ADDENDUM NO.: 3

Description: Furnish, Deliver, and Install AV

Project: CCNY Aronow Theater

Specifics of the Addendum: The purpose of Addendum No. 3 is to respond to Requests for Information.

REV	/ISIONS	
Rev No	Description	Date:
	Bulletin # 3	2/28/2025
3	ADDENDUM # 3	9/16/2025

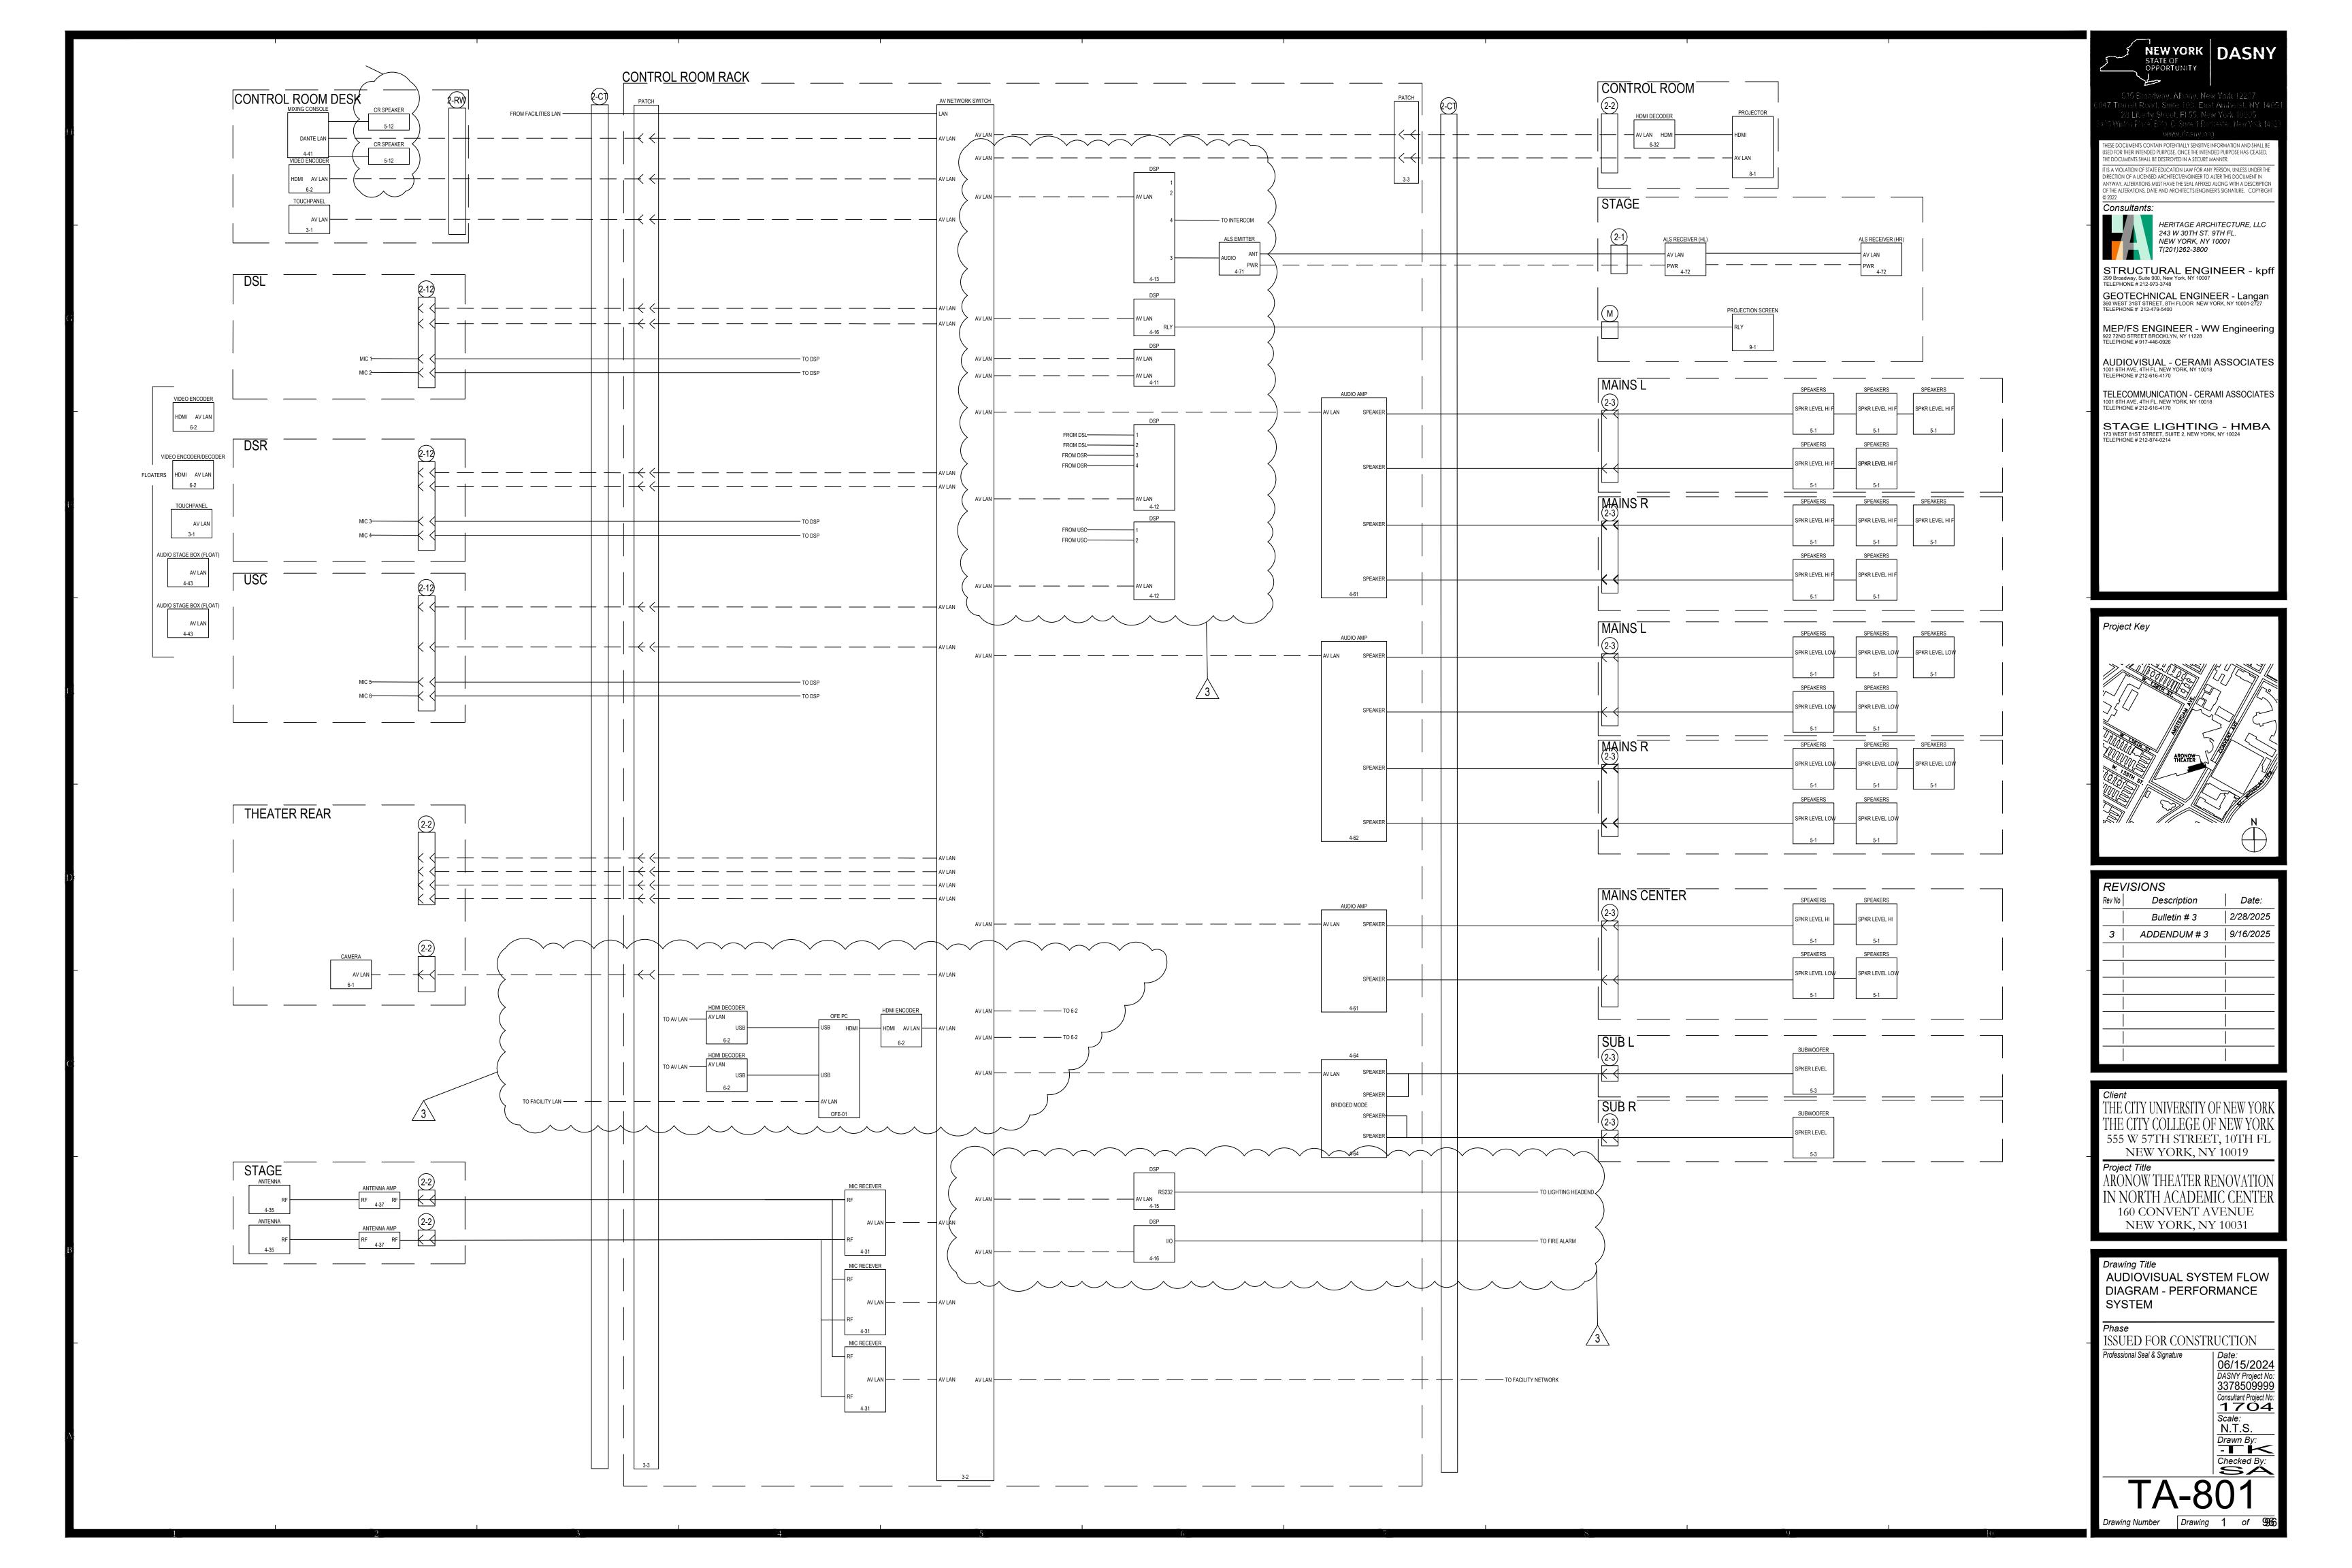
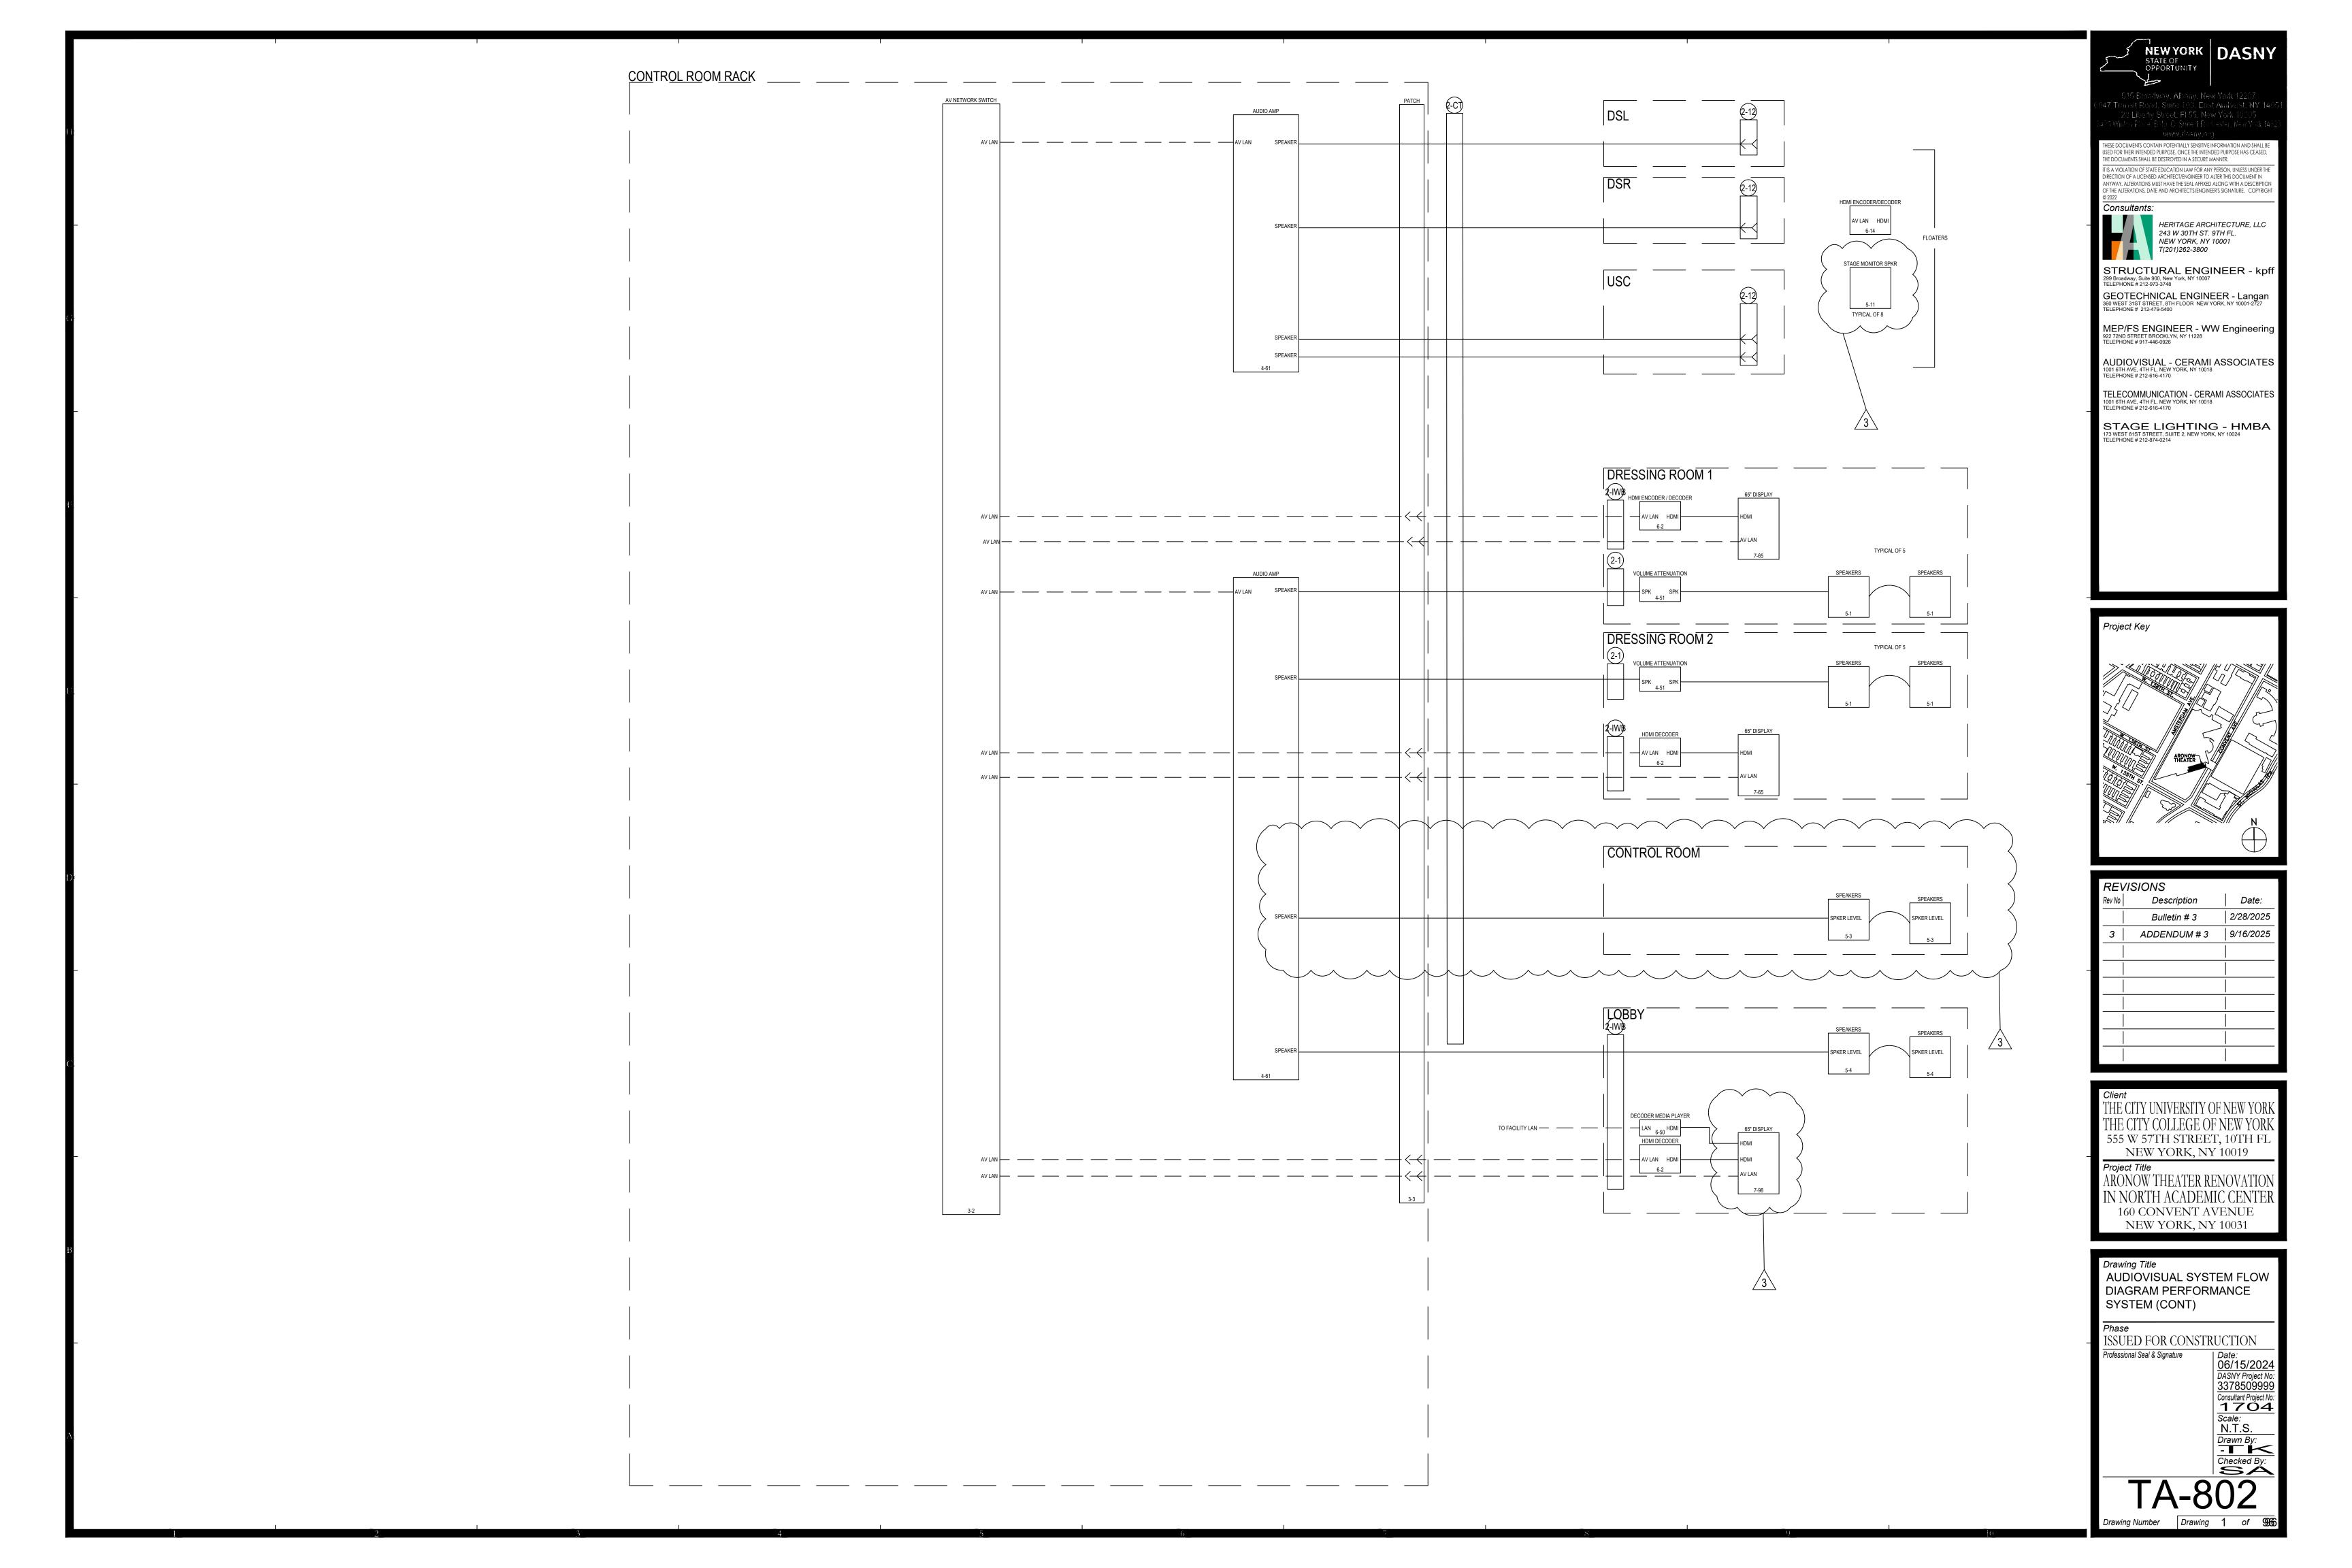
- **A7.** They are portable accessories. Some portable accessories are not shown in drawings such as mics, stands, DI boxes, etc.
- **Q8.** Both the BOM and flow sketches mention the Vaddio AV Bridge (999-9595-000). Could you clarify its intended use, given that the design already includes a QSC camera? We also observed that the flow sketches may show incorrect connections, as the bridge does not have the number of HDMI inputs depicted. Please confirm.

- A8. See updated TA-801, specification and BOM.
- **Q9.** The flow sketches show one HDMI decoder connected to the DSP for audio embedding. Could you please clarify its intended purpose, considering the QSC ecosystem is already in use?

- **Q25.** Sheet TA-801 shows 2 ceiling speakers in the control room being fed directly from the Yamaha TF5 digital mixer. Should the output of the mixer instead be feeding an amplifier which feeds the ceiling speakers? If so, can you specify the make and model of this amplifier?

- **A25.** See updated TA-802, specification and BOM.
- **Q26.** Sheet TA-801 shows an HDBT output of the Q-SYS NC-20X60 camera connecting to a rack mounted device labeled as "QUICK LINK". This camera doesn't appear to have an HDBaseT output. Would you be able to provide clarification on exactly how this camera will connect to the Vaddio AV Bridge?

- A9. See updated TA-801, specification and BOM.
- **Q10.** The flow sketches show 1 stage monitor, while the BOM lists 3. Could you please confirm the correct quantity?

- A26. See updated TA-801.
- **Q27.** Where is all of the existing equipment that was already uninstalled from the Theater currently being stored, and where will the AV contractor be transporting this equipment from?
